ADDENDUM #04

INVITATION TO BID #01

**WESTERN CONNECTICUT STATE UNIVERSITY
RENOVATIONS TO
HIGGINS HALL & HIGGINS ANNEX**

STATE PROJECT NO: BI-RD-290-CMR

1 ROOF PLAN - AREA A
1/8" = 1'-0"

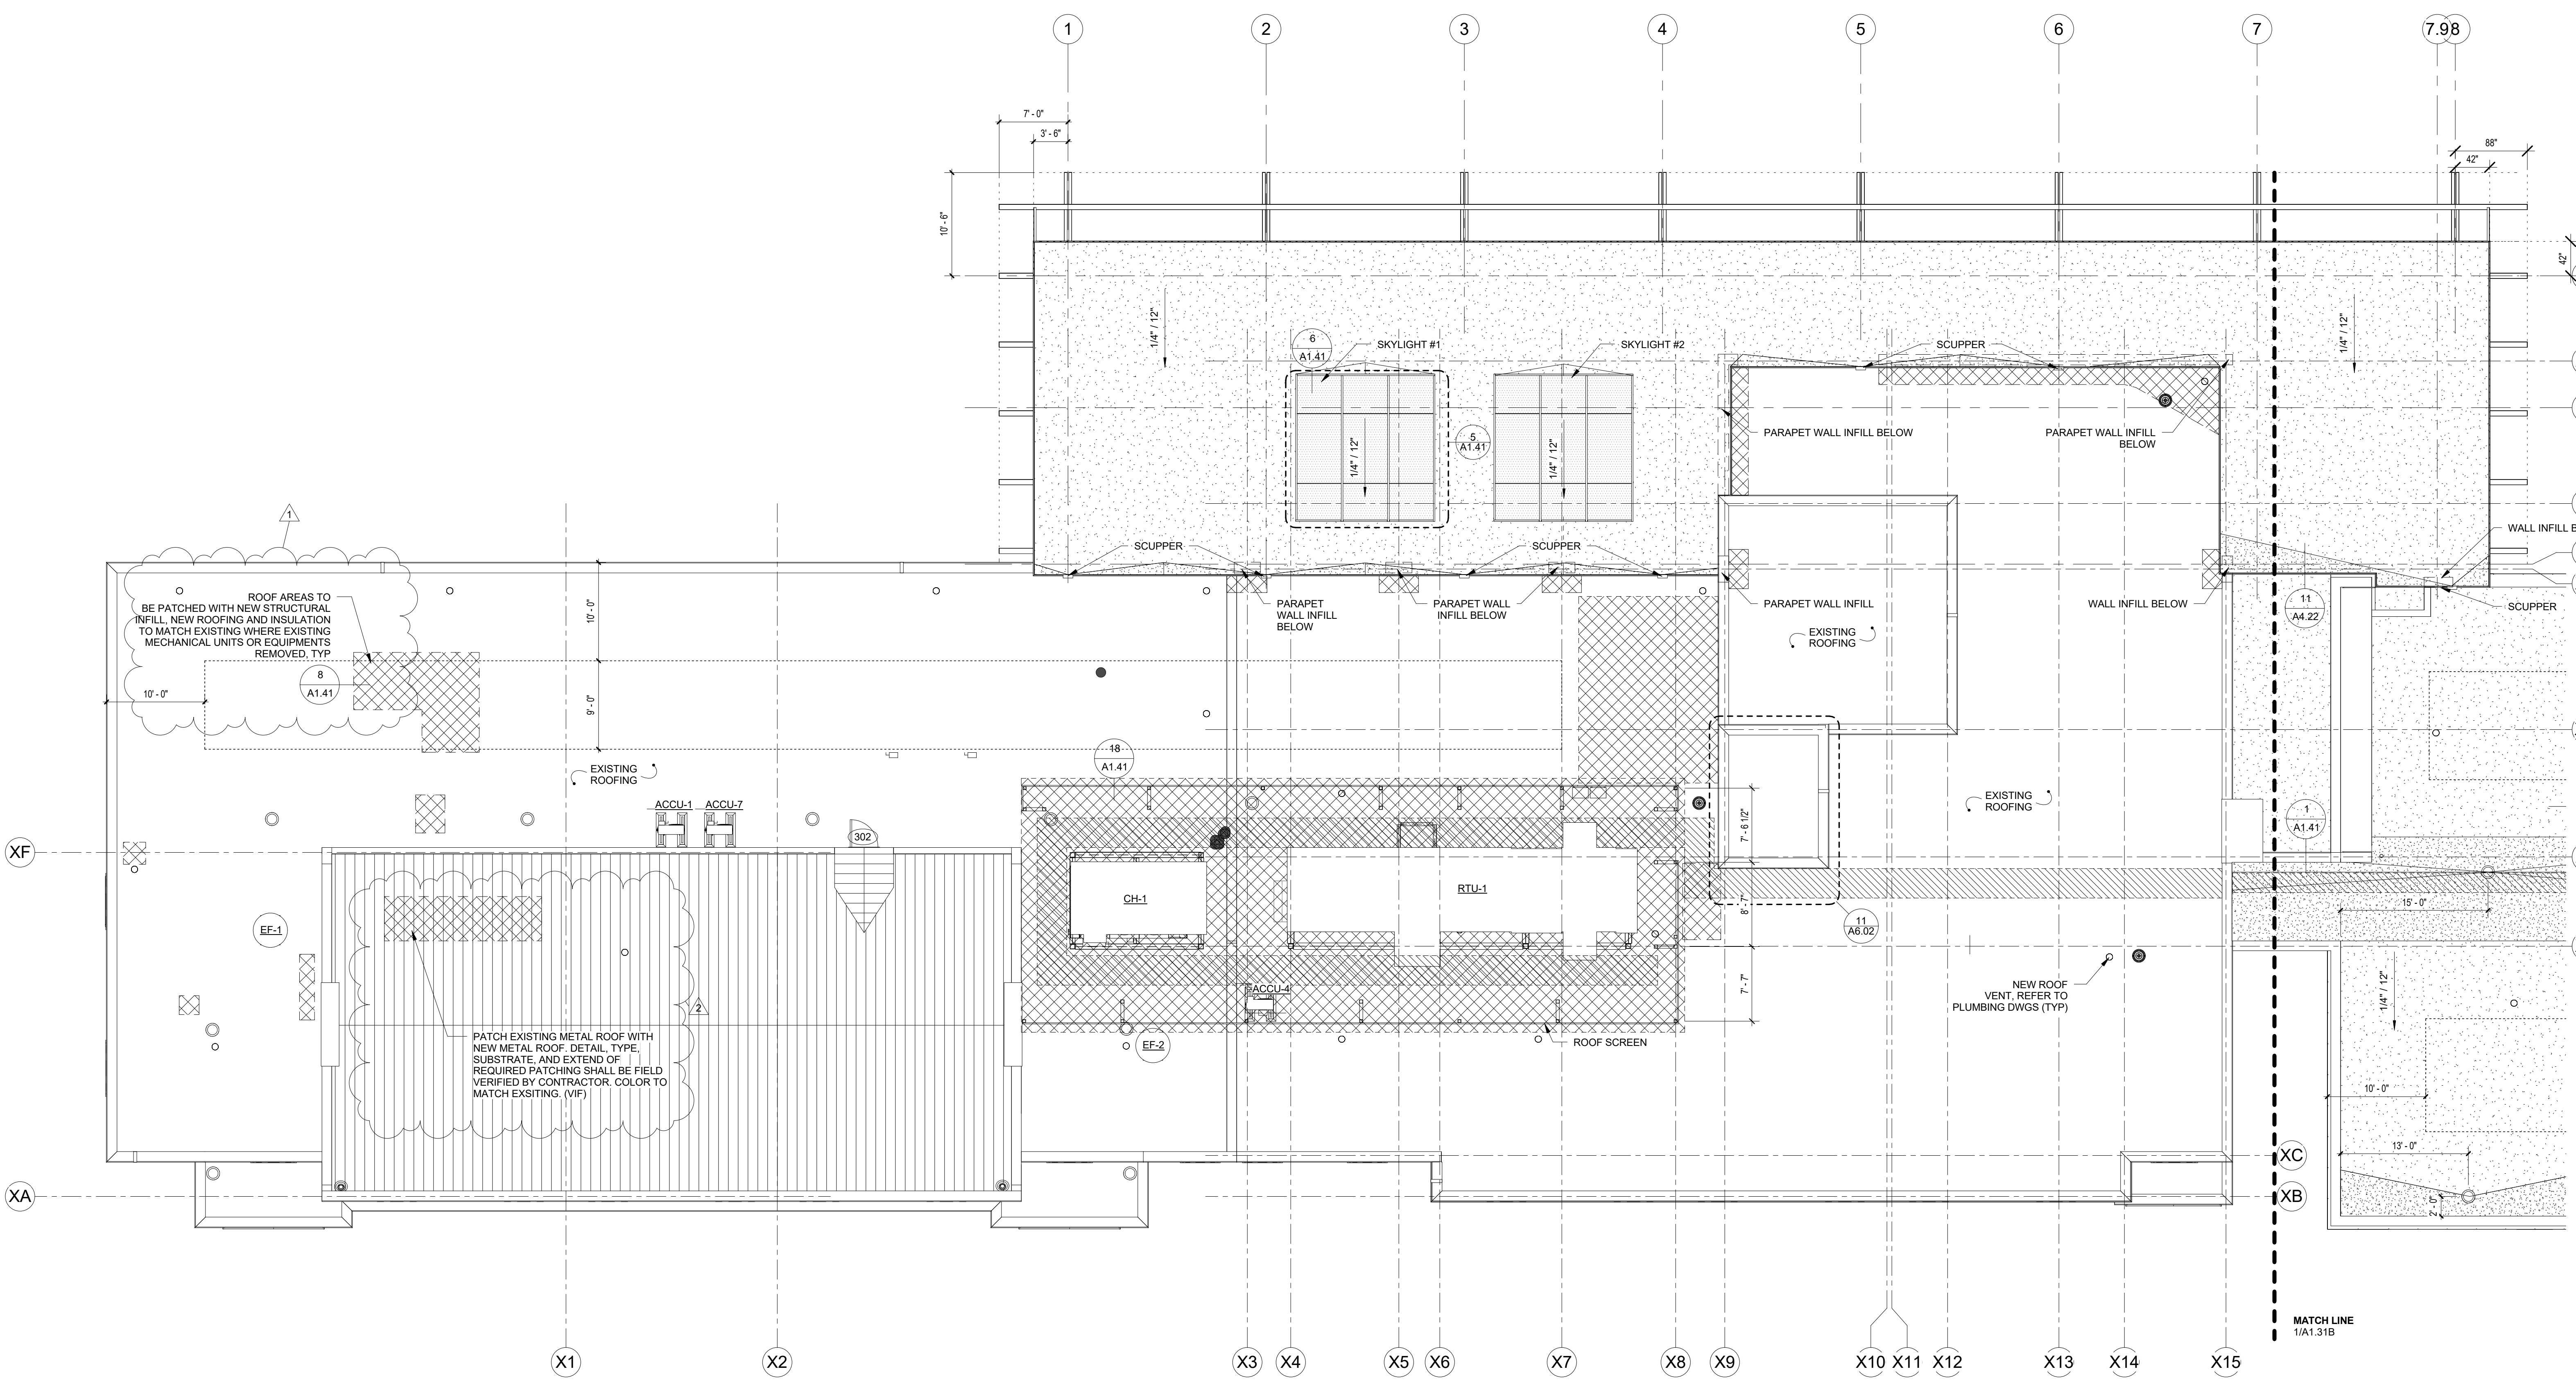
1. D1.31B:
 - Remove note ETR (Existing to Remain) for existing roof hatch. Curb and associated flashing shall be removed. Refer to A1.31B and A1.41 for new roof hatch location and detail.

2. A1.31A:
 - Replace drawing with revised A1.31A.
3. A1.41:
 - Replace drawing with revised A1.41.
4. A11.01, A11.02
 - Add note on remarks as to read "ALL EXISTING DOOR FRAMES RECEIVING NEW DOOR PANEL SHALL BE REMOVED AND REINSTALLED TO INSTALL CARD READER, CONTACTS OR ELECTRIFIED STRIKE WHERE REQUIRED UNLESS OTHERWISE SHOWN ON DETAILS OF A11.02. PARTIALLY DEMO, PATCH AND PAINT EXISTING WALL FOR CABLE RUN AND REINSTALLATION OF DOOR AS REQUIRED."

ROOF INFILL, TIE-IN AND NEW DECK INSTALLATION DETAIL
1 1/2" = 1'-0"

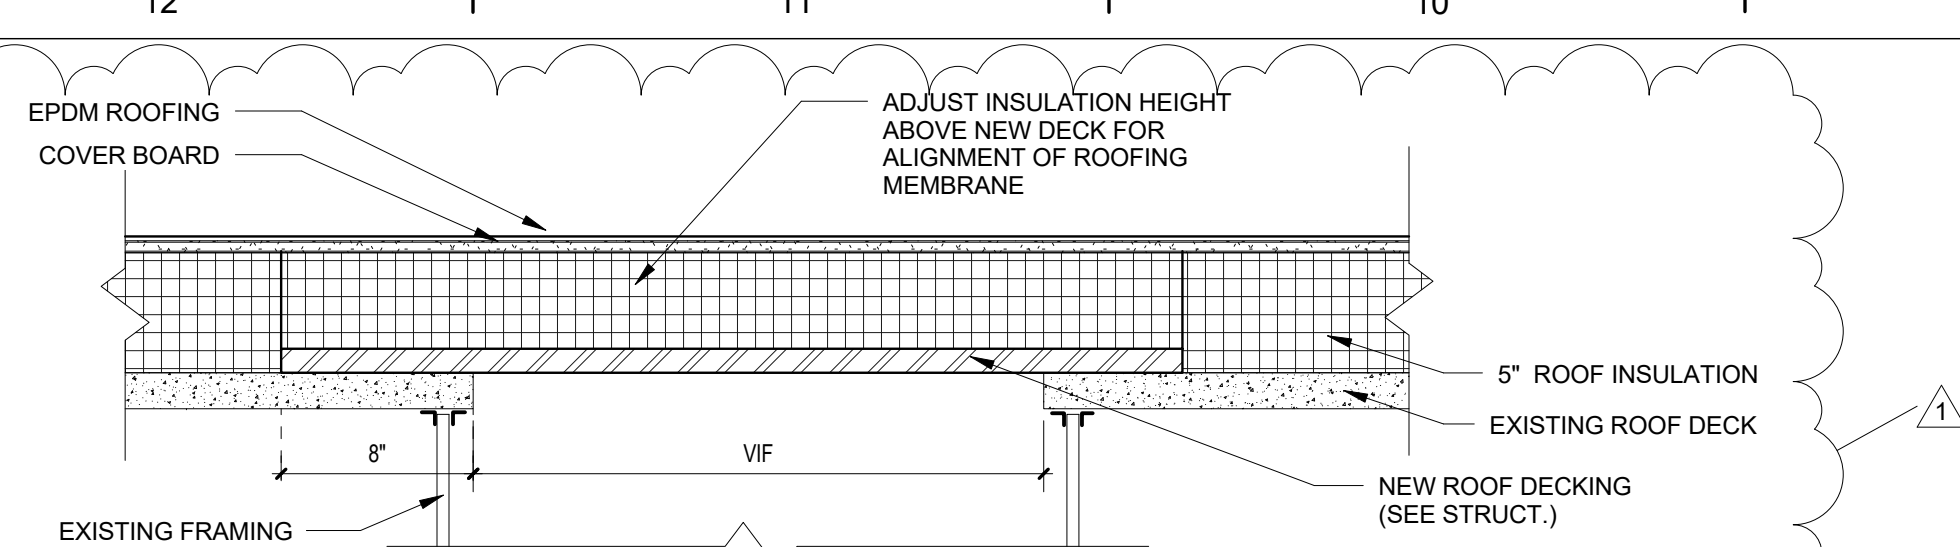
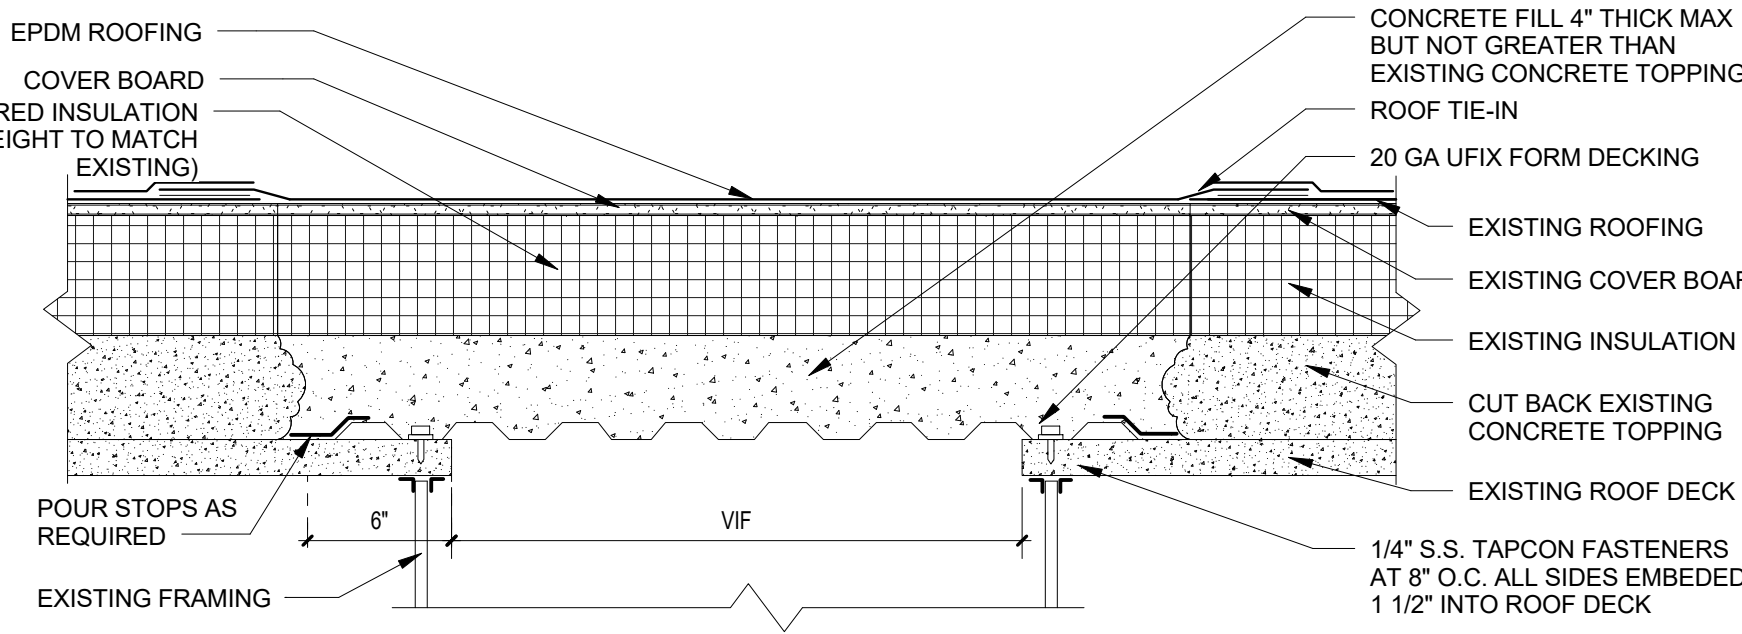
RFI BB Question – Reference D1.31A note 14, provide details for capping this condition and similar.

Answer – *Yes. The roof shall be patch to match existing insulation and roofing. The roofing shall be filed verified. Also see details for patching shown on revised Architectural and Structural Drawings included with this Scope.*

1 ROOF FRAMING PLAN
S1.31 1/8" = 1'-0"

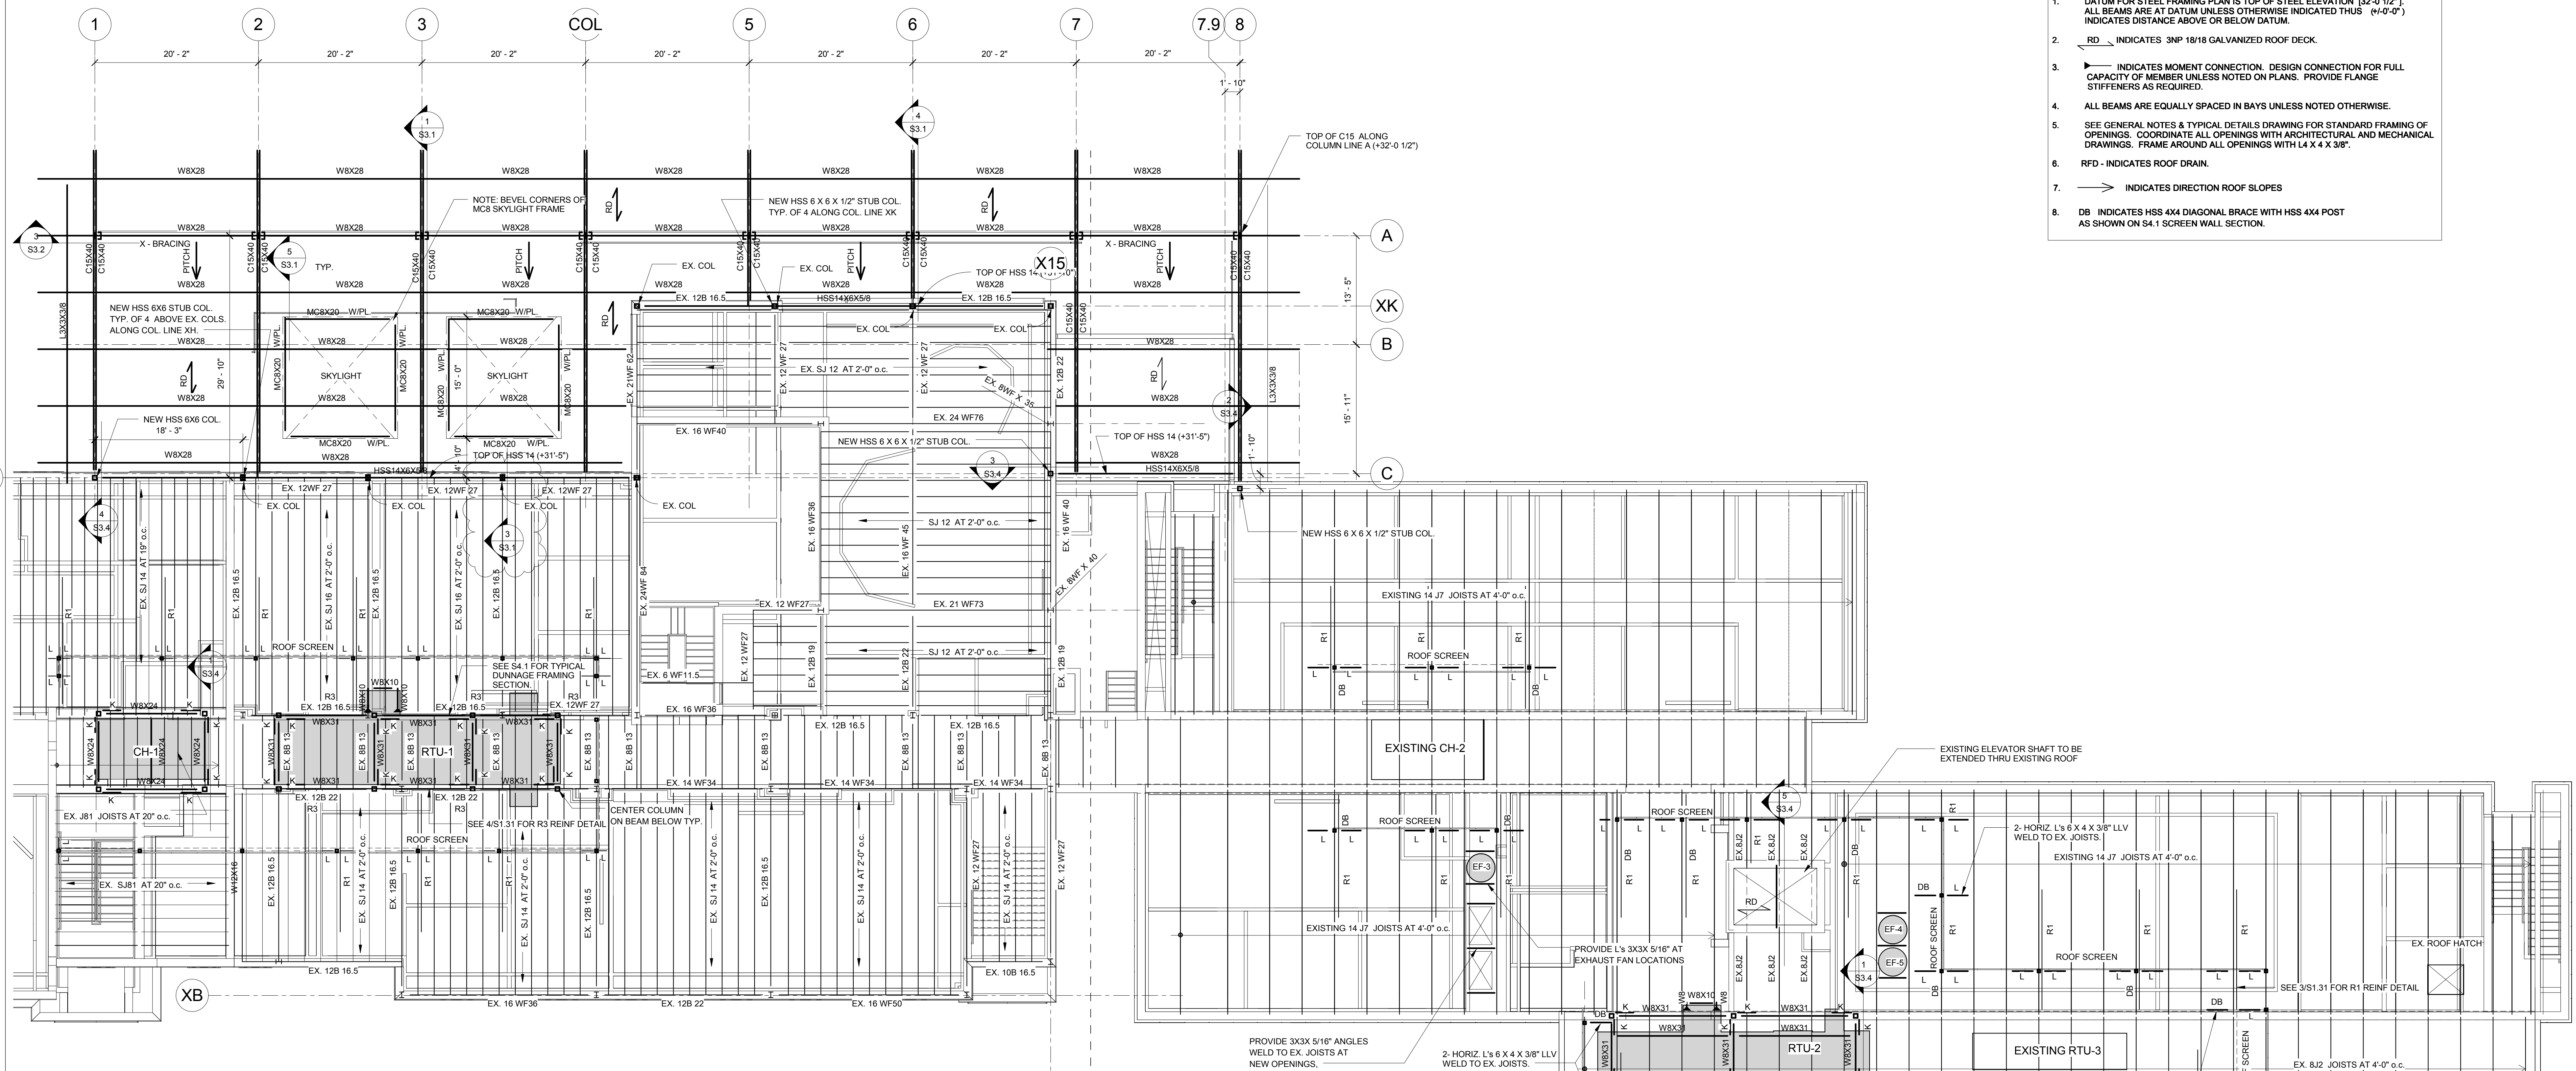
- RFI C Question** – No attachment details for new masonry parapets? Vertical dowels welded to existing spandrel required?
Answer – Refer to revised structural drawings in Supplement #2.

5. S1.31:
 - Replace drawing with revised S1.31.
6. S3.1:
 - Replace drawing with revised S3.1.
7. S4.1
 - Replace drawing with revised S4.1
